## SERVICE BULLETIN

**APPLICABILITY:** 2014-17MY Forester Turbo **NUMBER:** 07-136-18  
**SUBJECT:** New Alternator Assembly to Address Engine Vibration at Idle and False DTCs P0300, P0301, P0302, P0303 and P0304 **DATE:** 07/18/18

The reference illustrations below show examples of “Normal” and “Abnormal” SSM4 data.

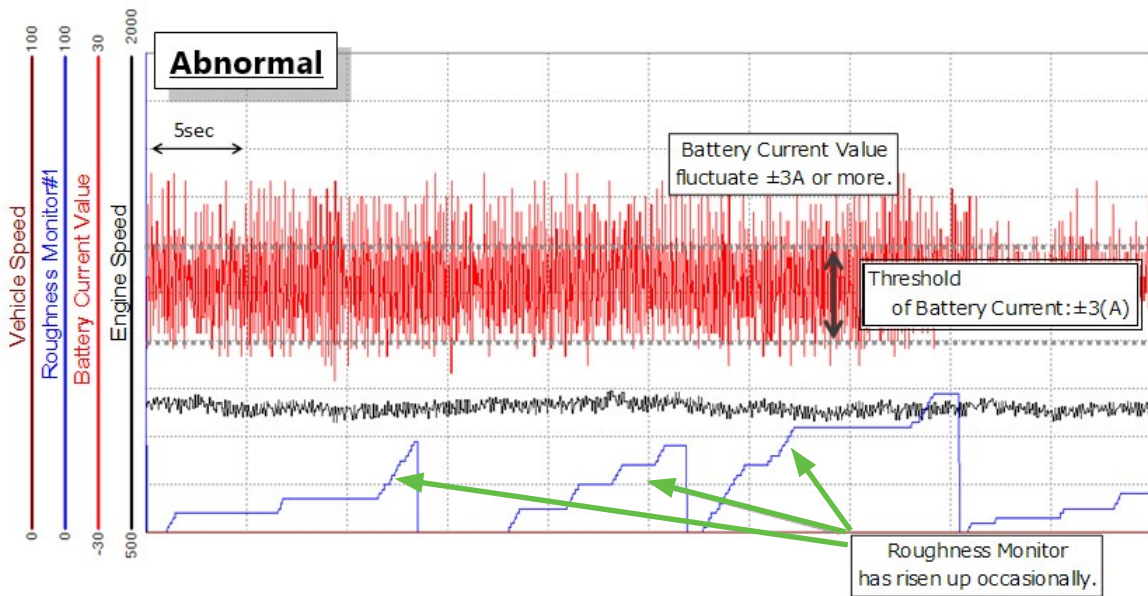
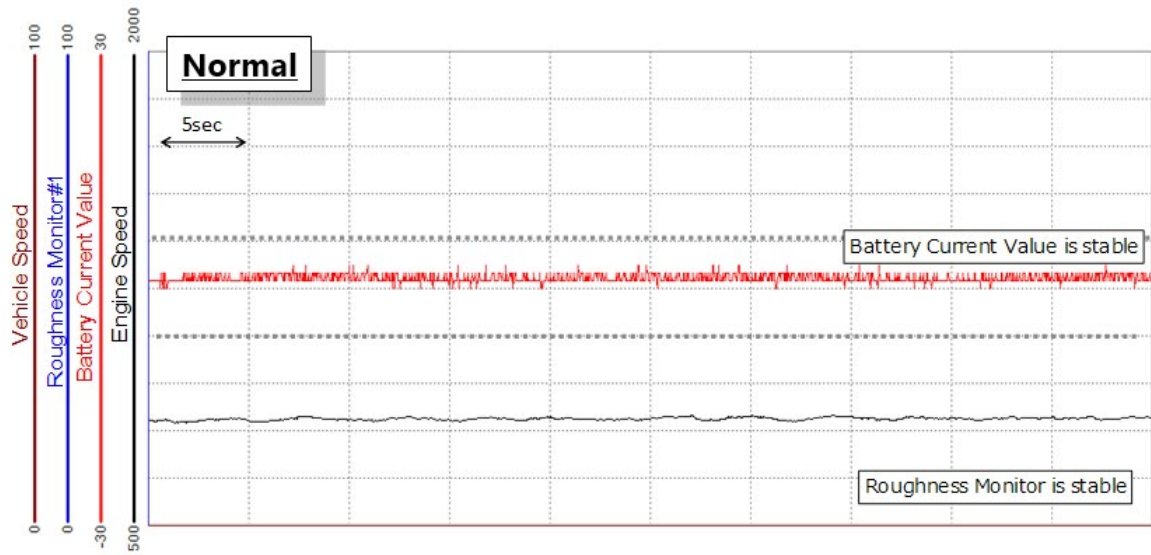
Resonance and / or oscillation between the alternator, drive belt and belt tensioner may cause the knock sensor to falsely identify a misfire condition and cause the engine misfire DTC(s) to set. To ensure a proper diagnosis, always determine the root cause of any misfire DTC BEFORE attempting any repairs. Refer to the procedure below for how to diagnose this condition:

- If a Battery Current value of more than +/- 3A is confirmed AND the roughness monitor value for the cylinder(s) setting the DTC keeps increasing, replace the alternator assembly, v belt and tensioner assembly **as a set** with the new parts listed in the table above.

The abnormalities shown above for the Roughness Monitor and Battery Current Value are a result of resonance originating in the alternator pulley and tensioner assemblies. Although any of the listed DTCs may set, there is not an actual misfire of the engine.
